# POST OAK TRACT

**Z-46  
(2012)  
Revised  
Site Plan**

## ZONING PLAN

# Z-46

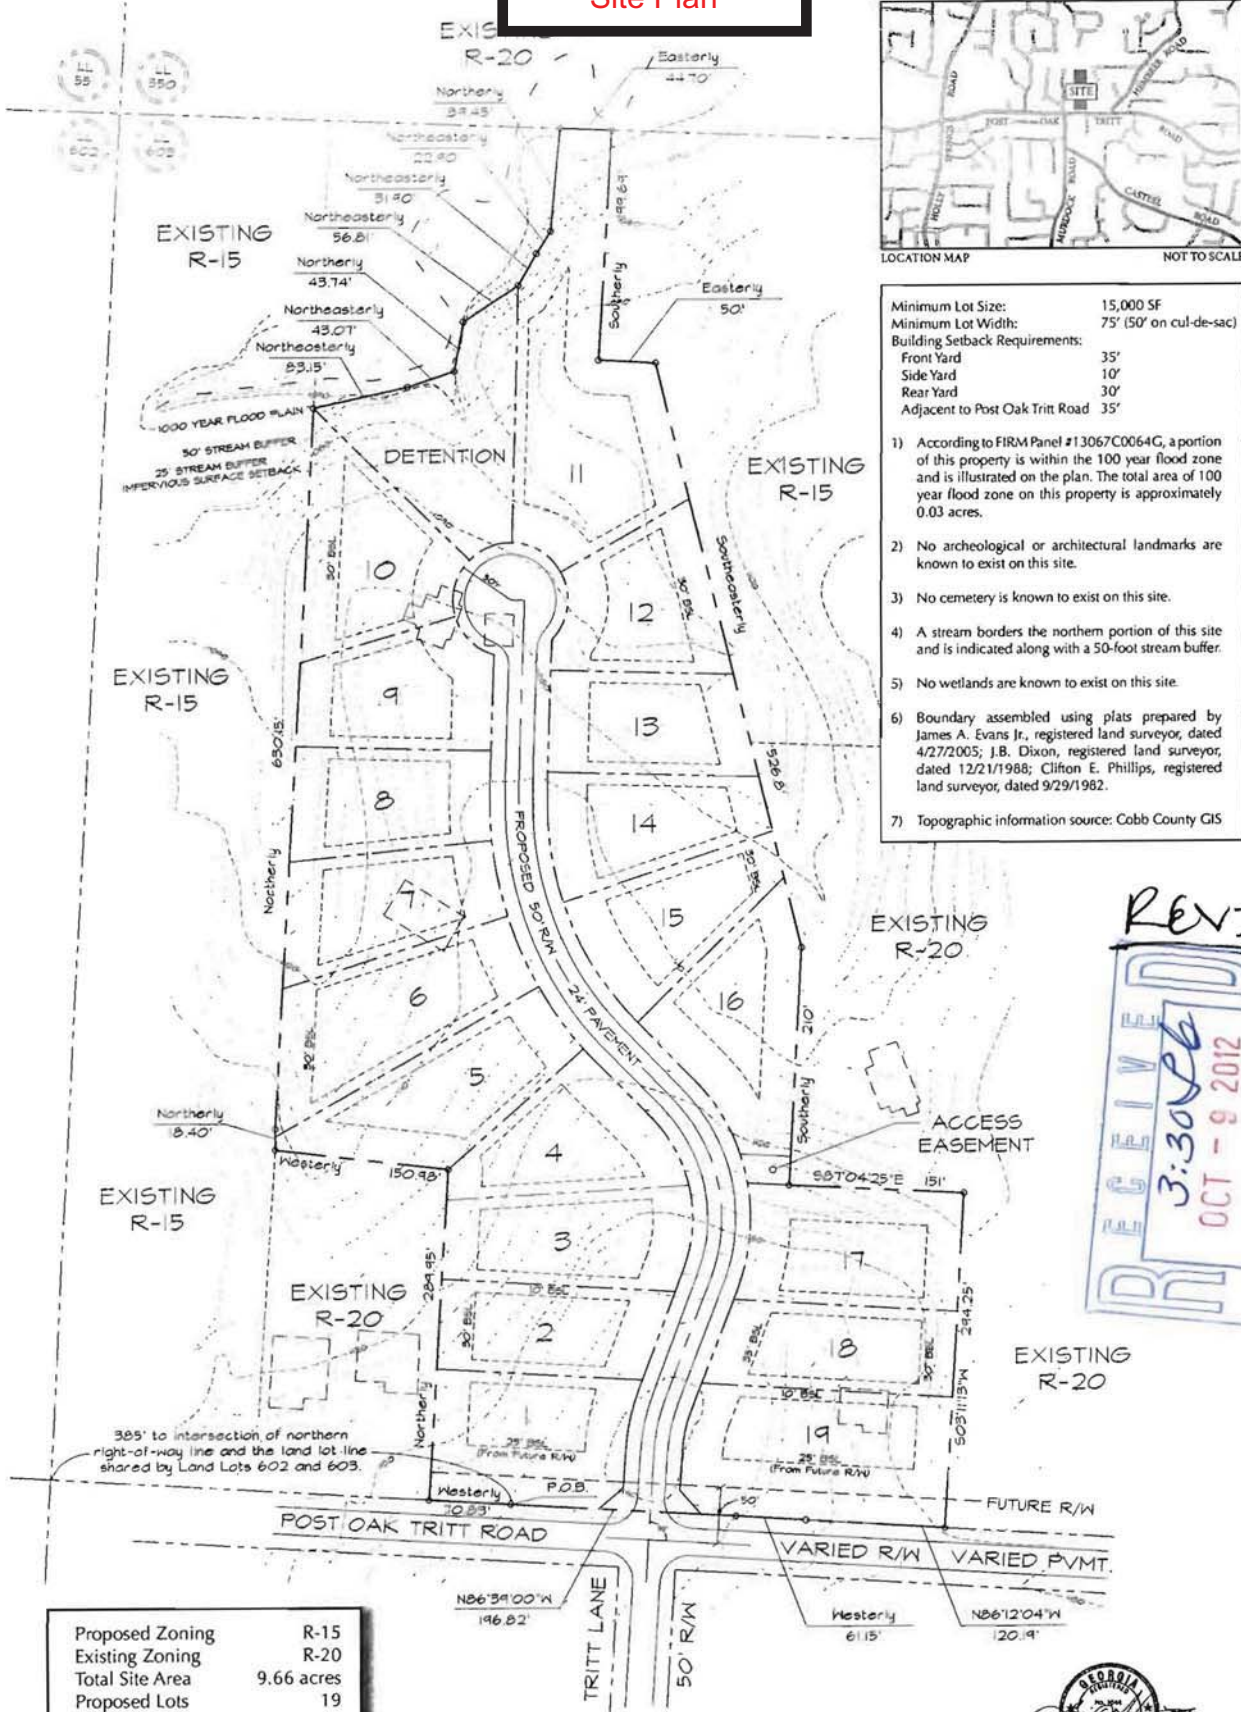
1. This entire site drains to the north to an unnamed tributary to Piney Grove Creek. The site is dominated by a ridge line that divides the parcel approximately in half. Since the proposed road alignment will lie approximately along this ridge line, drainage easements will be required along the rear of all but two of the proposed lots to control runoff from the site. This requirement must be taken into account if any perimeter landscape buffers are proposed.

Post Oak Tritt Road is classified as an arterial and according to the available information the existing right-of-way does not meet the minimum requirements for this classification.

Recommend applicant consider entering into a development agreement pursuant of O.C.G.A. 36-71-13 for dedication of the following system improvements to mitigate traffic concerns: a) donation of right-of-way on the north side of Post Oak Tritt Road, a minimum of 50' from the roadway centerline.

Recommend curb, gutter, and sidewalk along Post Oak Tritt Road frontage.

Recommend curb and gutter along both sides and sidewalk along one side of proposed development roadway.

Recommend a deceleration lane on Post Oak Tritt Road for the entrance.

- Revised site plan received by the Zoning Division on October 9, 2012, with the District Commissioner approving minor modifications;
- Water and Sewer comments and recommendations;
- Stormwater Management comments and recommendations;
- DOT comments and recommendations; and
- Owner/developer to enter into a Development Agreement pursuant to O.C.G.A. §36-71-13 for dedication of system improvements to mitigate traffic concerns.
